ONYX PLAZA JSP19-01

Public hearing at the request of Potluri Estates and Dice Holdings for Preliminary Site Plan, Woodland Permit, and Storm water Management plan approval. The development area is approximately 14.29 acres and is located north of Ten Mile Road along the west side of Novi Road in Section 22. The applicant is proposing a 34,173 square foot, 9-screen theater with 709 seats and 18,178 square foot retail building within the B-3 zoned area with associated parking and site improvements on the adjacent parcel zoned OS-1.

PLANNING REVIEW

Review Date: April 03, 2019
Review Type: Preliminary Site Plan
Project Name: JSP 19-01 Onyx Plaza
Plan Date: March 11, 2019
Prepared by: Sri Ravali Komaragiri
Contact: **E-mail:** skomaragiri@cityofnovi.org **Phone:** 248.735.5607

SHEET #
A.201

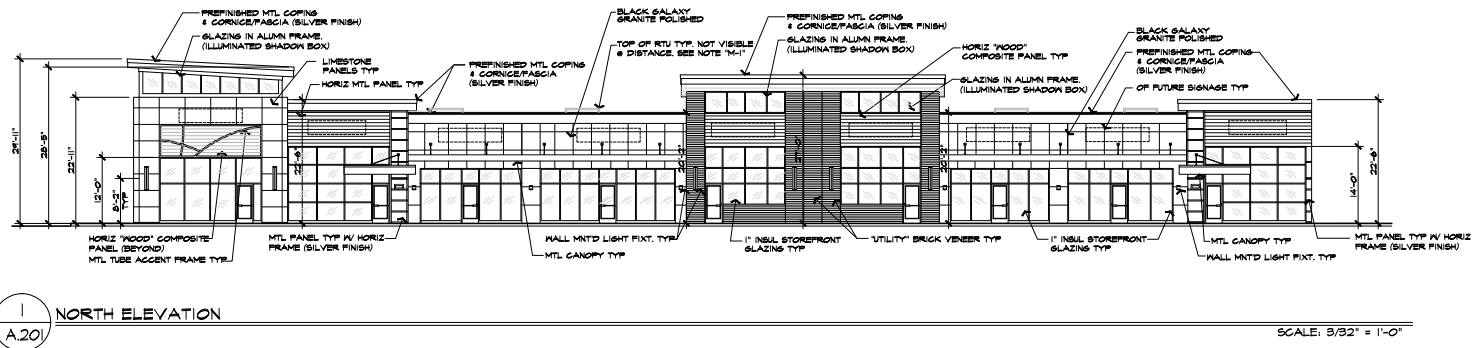
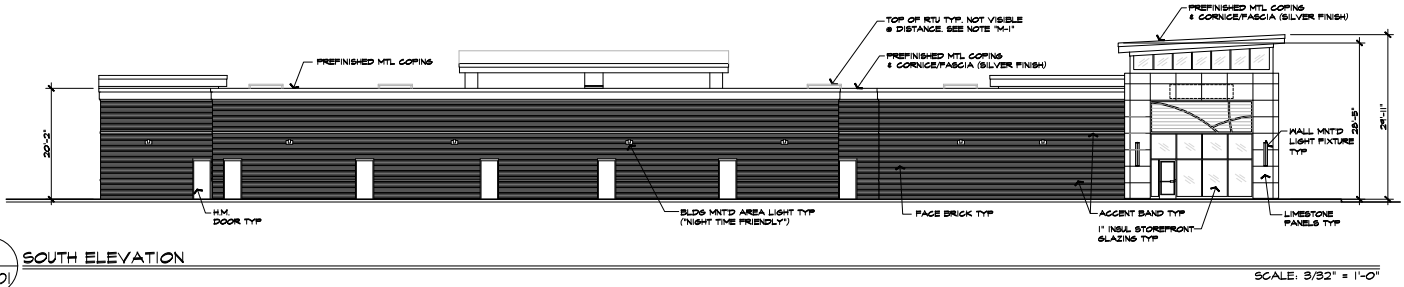
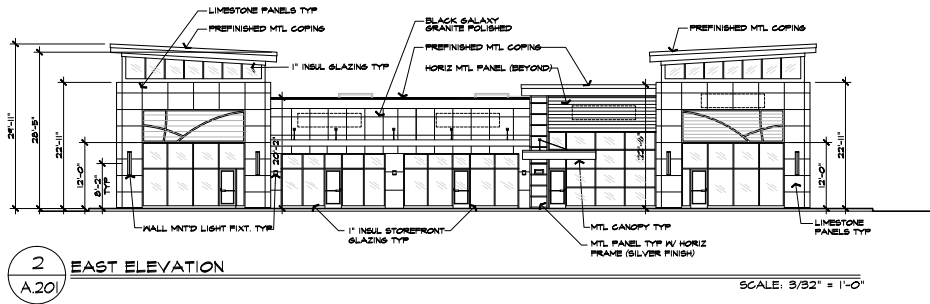
- d. A Section 9 waiver for underage of brick on eastern façade (30% minimum required, 0% proposed) due to extensive use of granite and marble, which is hereby granted;

- f. Facade Review: Façade recommends approval. A Section 9 waiver is required for underage of brick on east façade. A façade sample board is required prior to Planning Commission meeting.

Figure 1. City of Novi Regulated Wetland & Woodland Map (approximate parcel boundary shown in red). Regulated Woodland areas are shown in green and Regulated Wetland areas are shown in blue.

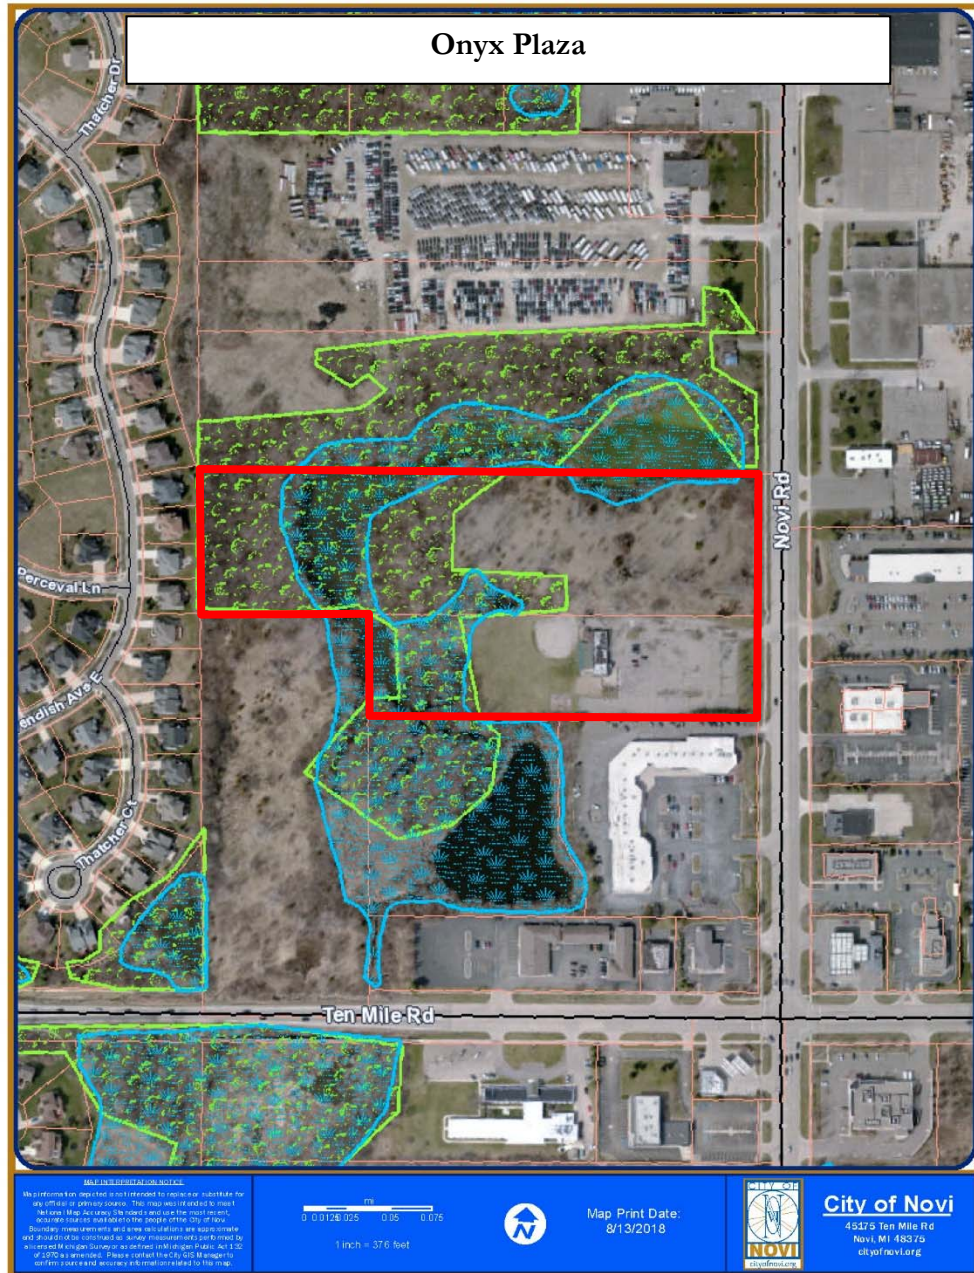
Based on our review of the application, Novi aerial photos, Novi GIS, the City of Novi Official Wetlands and Woodlands Maps (see Figure 1, attached), and our wetland verification site inspection conducted on June 19, 2018 it appears as if this proposed project site contains areas mapped as City-Regulated Wetlands/Watercourses. The site appears to contain wetland/watercourse areas that are regulated by the City of Novi as well as the Michigan Department of Environmental Quality (MDEQ). The focus of the site inspection was to review site conditions in order to determine whether City-regulated wetlands are found on-site.

ECT's in-office review of available materials included the City of Novi Regulated Wetland and Watercourse map (see Figure 3), USGS topographic quadrangle map, NRCS soils map, USFWS National Wetland Inventory map, and historical aerial photographs (from Oakland County). Based on our review of this information it appears as if this proposed project site contains areas mapped as City-Regulated Wetlands/Watercourses. The site appears to contain wetland/watercourse areas that are regulated by the City of Novi as well as the Michigan Department of Environmental Quality (MDEQ). The focus of the site inspection was to review site conditions in order to determine whether City-regulated wetlands are found on-site.

Figure 1. City of Novi Regulated Wetland & Woodland Map (approximate parcel boundary shown in red). Regulated Woodland areas are shown in green and Regulated Wetland areas are shown in blue.

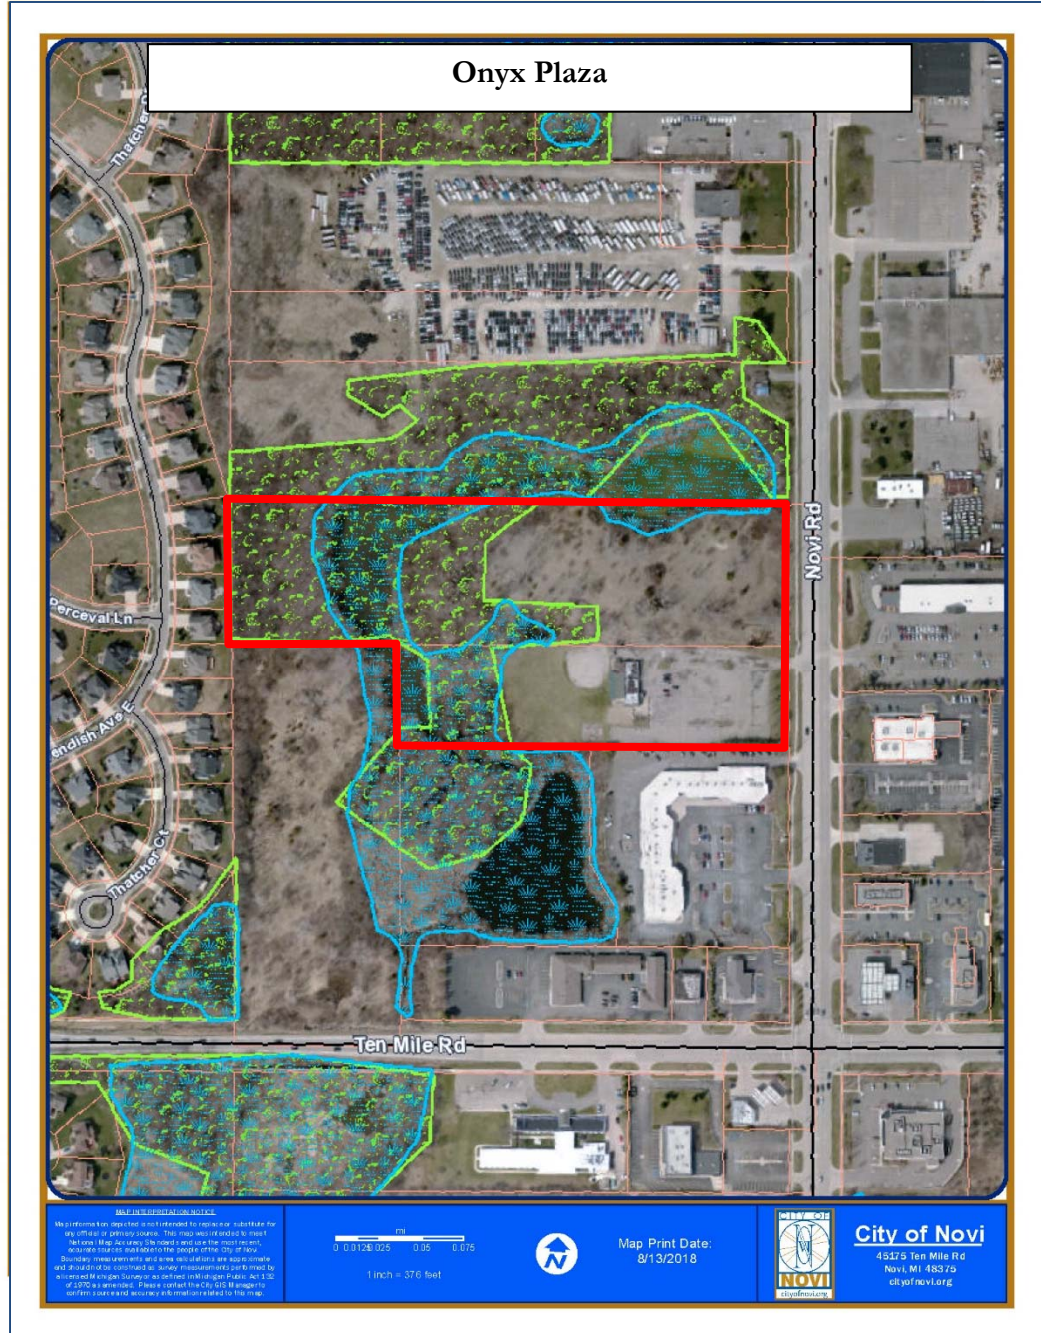
Based on our review of the Plan, Novi aerial photos, Novi GIS, City of Novi Official Wetlands and Woodlands Map (see Figure 1), and on-site evaluation this proposed project site contains areas indicated as Regulated Woodlands as well as Regulated Wetlands. The western portion of the southern parcel, and the western 1/2 of the northern parcel are mapped as containing City-regulated woodland.

ECT has reviewed the City of Novi Official Woodlands Map and completed an onsite Woodland Evaluation on June 19, 2018. ECT's in-office review of available materials included the City of Novi Regulated Woodland map and other available mapping. As noted above, the western portion of the southern parcel, and the western ½ of the northern parcel are mapped as containing City-regulated woodland (see Figure 1). The proposed limits of disturbance for the proposed project does include areas mapped as City-Regulated Woodlands. Specifically, proposed parking area as well as the stormwater detention basin area have been sited within City-Regulated Woodlands.
